Access Compliance Report

Public Rights-of-Way

Intersection ID: 10023269	Main Street: CHELTON RIDGE LN	Cross Street: N/A	Location: NE
ADA ID: A27EEA79ED06	Ramp Type: BlendTrans1	Initial Pass/Fail: Fail	Overall Compliance: No
			Severity Score: 10

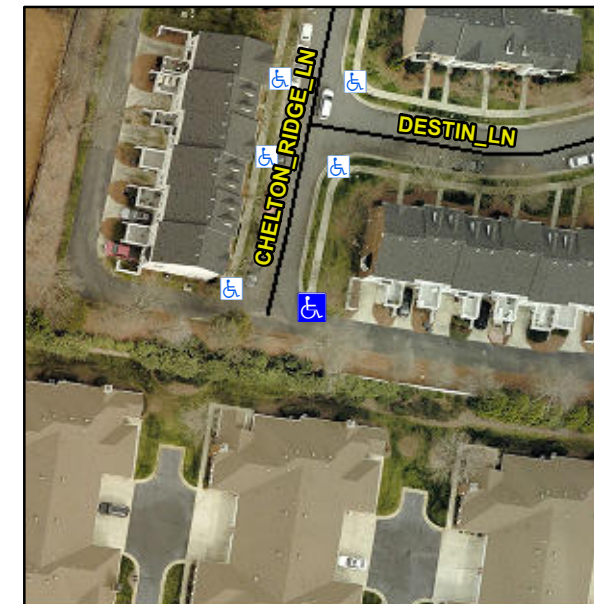
R304.5.1, R304.5.3

Compliance	Description	Data	Compliance	Description	Data
N/A	Ramp Length (in)	53.0	Yes	BlendTrans Slope (%)	4.8
No	Ramp Width (in)	45.0	No	BlendTrans XSlope (%)	2.3
N/A	Flare Type LT	N/A	N/A	Flare Type RT	N/A
N/A	Flare Slope LT (%)	N/A	N/A	Flare Slope RT (%)	N/A
N/A	Flare Traversable LT?	N/A	N/A	Flare Traversable RT?	N/A
N/A	Landing Length (in)	N/A	N/A	DWS Provided?	N/A
N/A	Landing Width (in)	N/A	N/A	DWS Contrast?	N/A
N/A	Landing Slope (%)	N/A	N/A	DWS Length (in)	N/A
N/A	Landing X Slope (%)	N/A	N/A	DWS Full Width?	N/A
N/A	Landing Curb? (Y/N)	N/A	N/A	DWS Offset (in)	N/A
N/A	Shared Landing?	N/A			
N/A	Gutter Ponding?	N/A	N/A	Gutter Slope (%)	N/A
N/A	Gutter Lip Ht (in)	N/A	N/A	Gutter X Slope (%)	N/A
N/A	Painted X Walk1?	No	N/A	Painted X Walk2?	No
	X Walk 1 Direction	To NW		X Walk 2 Direction	To S
	X Walk 1 Width (in)	N/A		X Walk 2 Width (in)	N/A
	X Walk 1 Slope (%)	1.8		X Walk 2 Slope (%)	0.2
	X Walk 1 X Slope (%)	0.9		X Walk 2 X Slope (%)	0.7

Remove & Replace Curb Ramp With Two New Directional Ramps or Equivalent.
